K3 KIT ASSEMBLY MANUAL ERRATA

Rev. C-2, November 20, 2007

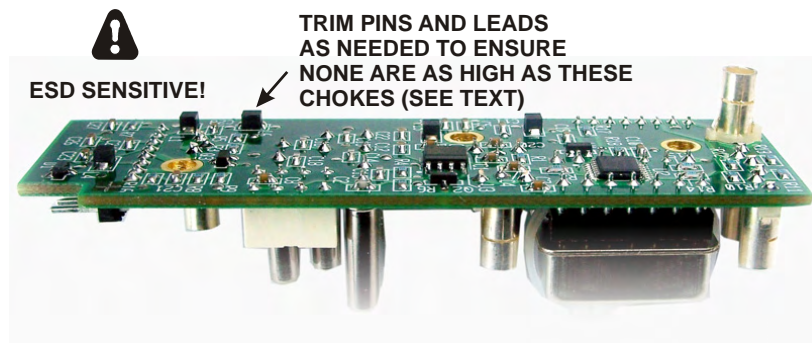
1. Page 9, add this CAUTION to the page:

⚠ DO NOT ADJUST THE TURNS ON ANY OF THE TOROIDS!

The position of the turns on many toroids has been adjusted at the factory to produce exactly the inductance needed for the circuit to work properly. Any attempt to adjust their position to make the coil look “nicer” may seriously degrade the circuit performance.

Also, do not attempt to fix the turns or the toroids in place using adhesives or other materials! Experience has shown that the toroids are secure even when subjected to significant vibration over time, such when the radio is installed in trucks or aircraft. Putting anything on the toroid will alter its inductance, again degrading the circuit performance.

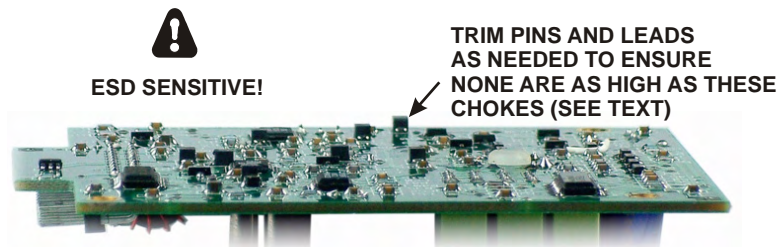
3. Page 42, add this step directly under the heading *KSYN3 Installation Procedure*:

Inspect the bottom of the KSYN3 board to ensure no leads are higher than the chokes as shown below. The chokes are the highest of the black surface-mount components on the board. Use your diagonal cutters to trim any excessively long leads close to the board.

⚠ CAUTION

The objective is to be certain no bare leads touch the front panel shield when the board is installed in the next step. Do not add spacers or insulating material between the board and the front panel shield. It is important for proper shielding of the circuits that the board sit very close to the shield.
